UNITED STATES PATENT AND TRADEMARK OFFICE

APPLICATION NO.	FILING DATE	FIRST NAMED INVENTOR	ATTORNEY DOCKET NO.	CONFIRMATION NO.
10/721,657	11/25/2003	Siddhartha Panda	FIS920030133US1	7420
28264 7590 01/18/2008 BOND, SCHOENECK & KING, PLLC ONE LINCOLN CENTER SYRACUSE, NY 13202-1355			EXAMINER VINH, LAN	
			ART UNIT 1792	PAPER NUMBER
			NOTIFICATION DATE 01/18/2008	DELIVERY MODE ELECTRONIC

Office Action Summary

**FIG. 9**

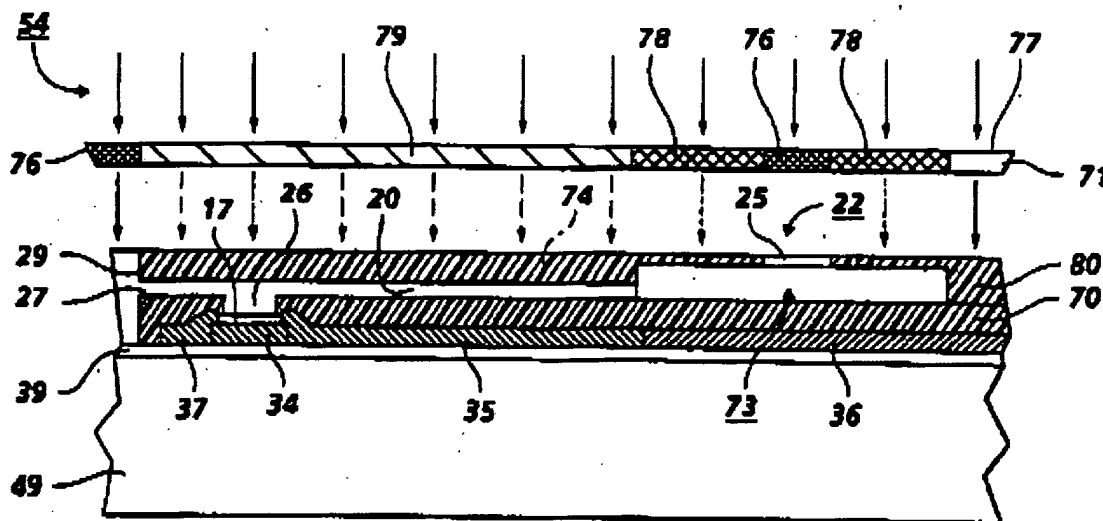
O'Neill discloses a graded mask 71, the graded mask 71 having variable areas 78, 79 permitting a smaller percentage of UV light transmission to reach the underlying layer, variable area 78 located /first region limits the transmission of UV light more than in area 79/second region so that the depth of reaction in the PR 80 is less under area 78 than under area 79 (col 8, lines 5-15, fig. 9), which reads on a mask/claimed filter comprises a first non-zero transmittance (lower) and a second non-zero transmittance that is different (higher) than the first

Regarding claim 12, fig. 9 of O'Neill shows region 78/first region comprises a perimeter of mask/filter 71, region 79/second region comprises a center portion of the mask/filter 71

Regarding claim 14, fig. 1 of O'Neill shows that the mask 71/filter having the peripheral region 78/first region and center region 79/second region aligned over circular-shaped wafer 49 which reads on the first region and second region are eccentric
